Morrison BRS0240(3)S Bridge Rail Shop Drawings_Resubmit 4 27 18.pdf

Approved AsNoted
DATE 04/27/18

HIGHWAY SAFETY CORP GLASTONBURY, CT 860-633-9445		CERTIFIED FABRICATOR
ITEM 525.335 BRIDGE RAIL, GALVANIZED, 3 RAIL BOX BEAM ITEM 621.725 GUARDRAIL APPROACH, GALVANIZED, 3 RAIL BOX BEAM VT RT 15A BRIDGE No. 1 TOWN OF MORRISTOWN - LAMOILLE COUNTY, VT BRS 0240(3) S		
GENERAL CONTRACTOR SUB CONTRACTOR LAFAYETTE		HSC JOB NO. 2236 SHEET NO. 4 of 8
DRAWN PAR	CHECKED DATE 04-09-18	SCALE NONE SIZE D

PARTIAL PLAN VIEW
SOUTHWEST CORNER

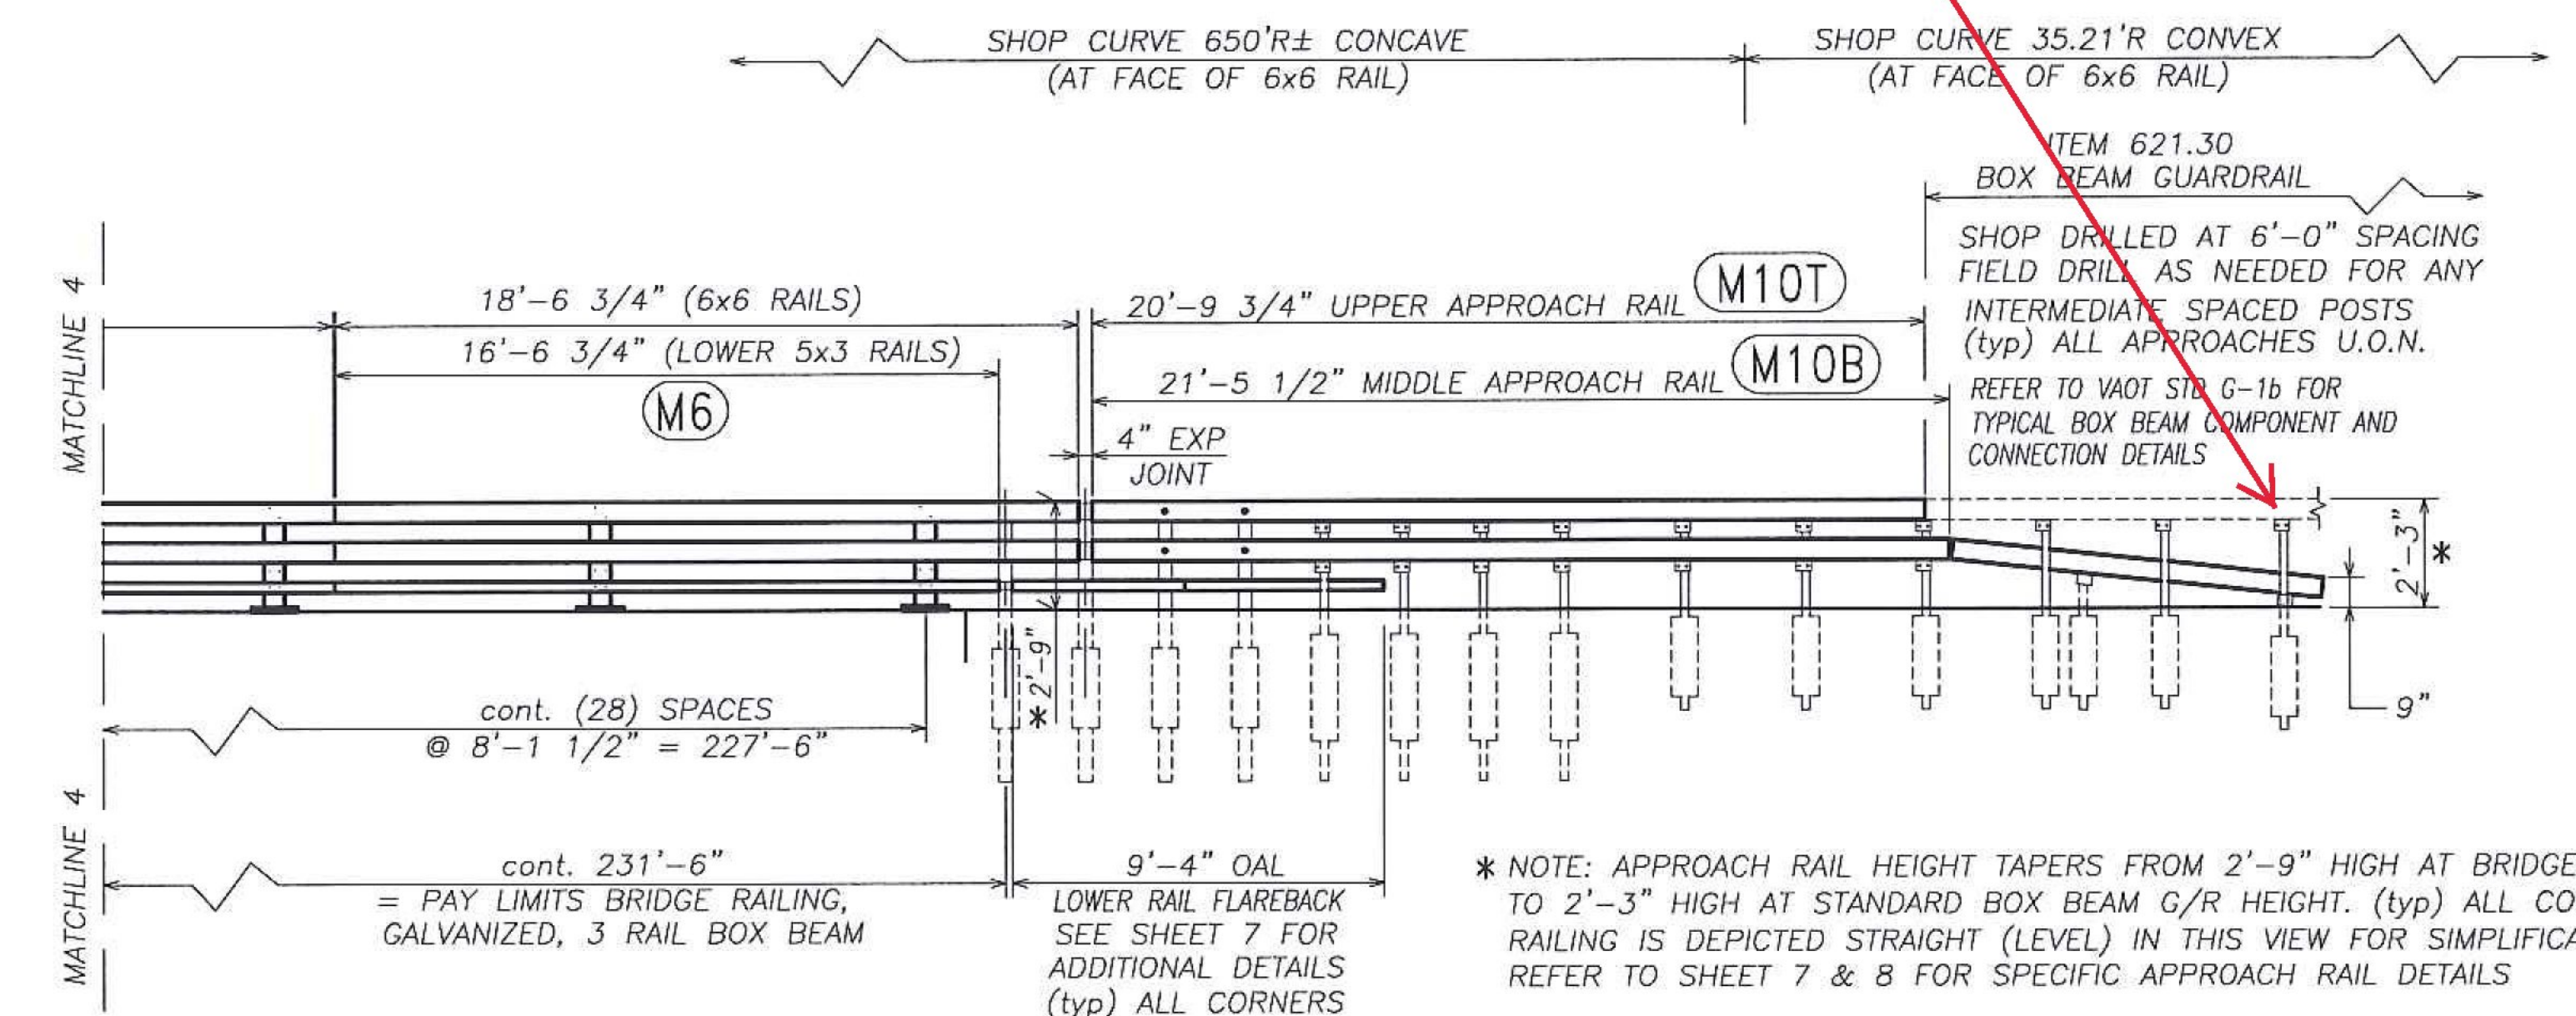
Won't affect fabrication but per standard S-364B, approach rail pay limits should extend to this post
